HISTORIC AND DESIGN REVIEW COMMISSION

November 18, 2020

HDRC CASE NO: 2020-487
ADDRESS: 523 SHOOK AVE
LEGAL DESCRIPTION: NCB 6328 BLK 1 LOT N 71.71 FT OF 28 AND 29
ZONING: R-5, H
CITY COUNCIL DIST.: 1
DISTRICT: Monte Vista Historic District
APPLICANT: Aaron Ely/CS CROSS
OWNER: Vicki Boyce/BOYCE JOHN K III & VICKI G
TYPE OF WORK: Window replacement
APPLICATION RECEIVED: October 26, 2020
60-DAY REVIEW: Not Applicable Due to City Council Emergency Orders
CASE MANAGER: Rachel Rettaliata

The applicant is requesting a Certificate of Appropriateness for approval to replace 2 window units with aluminum-clad wood windows.

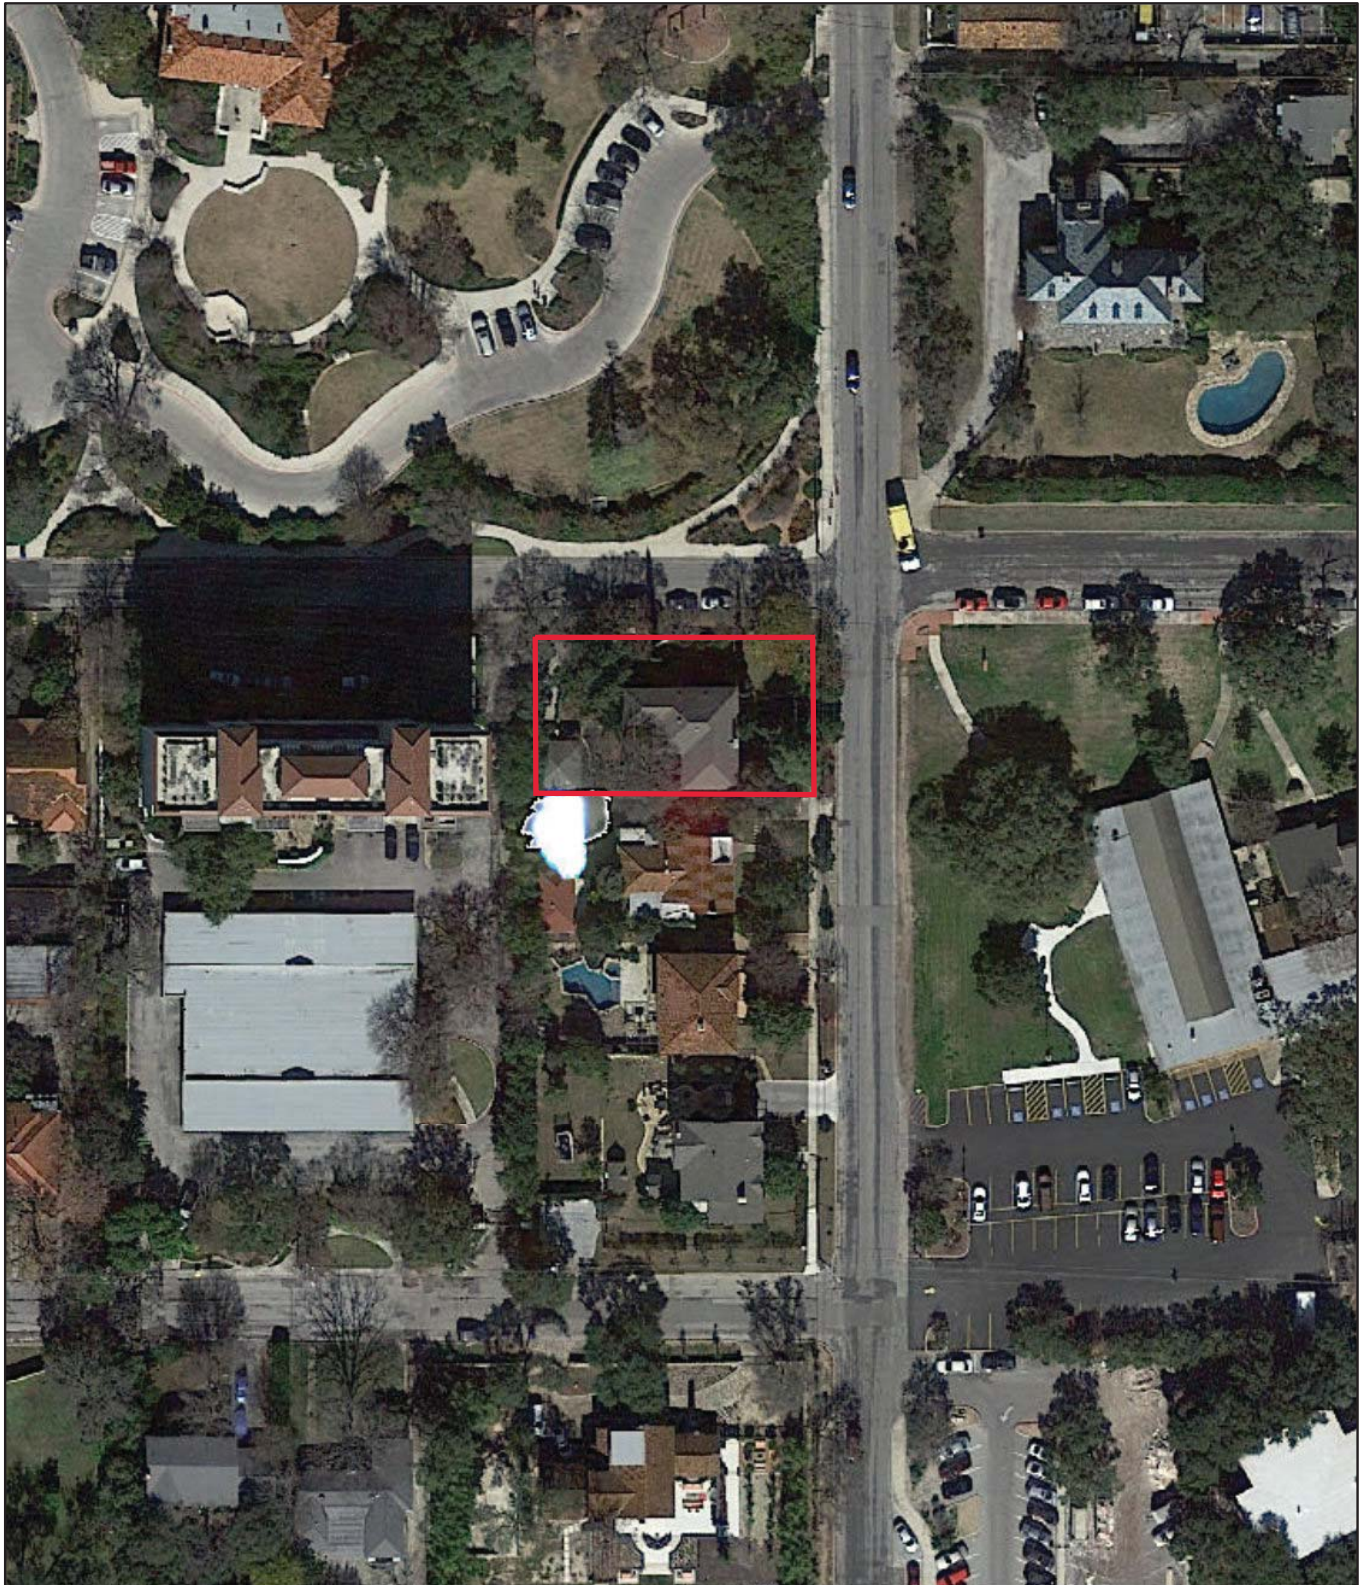
- b. **WINDOW REPLACEMENT: EXISTING CONDITION** – The applicant has proposed to replace 2 existing original wood windows. The applicant has proposed to replace a unit of 2 ganged windows at the rear of the property and a single window that faces Bushnell. Guideline 6.A.iii for Exterior Maintenance and Alterations states that historic windows should be preserved. Guideline 6.B.iv. for Exterior Maintenance and Alterations states that new windows should be installed to match the historic or existing windows in terms of size, type, configuration, material, form appearance, and detail when original windows are deteriorated beyond repair. The documentation provided does not provide evidence that the windows are deteriorated beyond repair. Staff finds the proposal inconsistent with the Guidelines and finds that the existing windows should be repaired in place.

- c. **WINDOW REPLACEMENT: REPLACEMENT PRODUCT** – The applicant has proposed to replace the existing one-over-one wood windows with aluminum-clad wood Pella Architect Traditional Double Hung Windows in Eldridge Gray. The proposed windows match existing Pella windows previously installed in the same room of the house. According to the Standard Specifications for Original Wood Window Replacement, meeting rails must be no taller than 1.25". Stiles must be no wider than 2.25". Top and bottom sashes must be equal in size unless otherwise approved. The proposed replacement product matches the existing product in material, configuration, and form. However, documentation has not been provided to show that the proposed replacement product meets the standard window specifications for the meeting rails and stiles.

Staff does not recommend approval based on findings a through c. Staff recommends that the applicant repair the existing windows in place.

- i. That the applicant replaces the existing windows with a fully wood window product that meets staff's standard window specifications and submits updated specifications to staff for review and approval. The windows should feature an inset of two (2) inches within facades and should feature profiles that are found historically within the immediate vicinity. Meeting rails must be no taller than 1.25" and stiles no wider than 2.25". White manufacturer's color is not allowed, and color selection must be presented to staff. There should be a minimum of two inches in depth between the front face of the window trim and the front face of the top window sash. This must be accomplished by recessing the window sufficiently within the opening or with the installation of additional window trim to add thickness. Window trim must feature traditional dimensions and architecturally appropriate sill detail. Window track components must be painted to match the window trim or concealed by a wood window screen set within the opening.
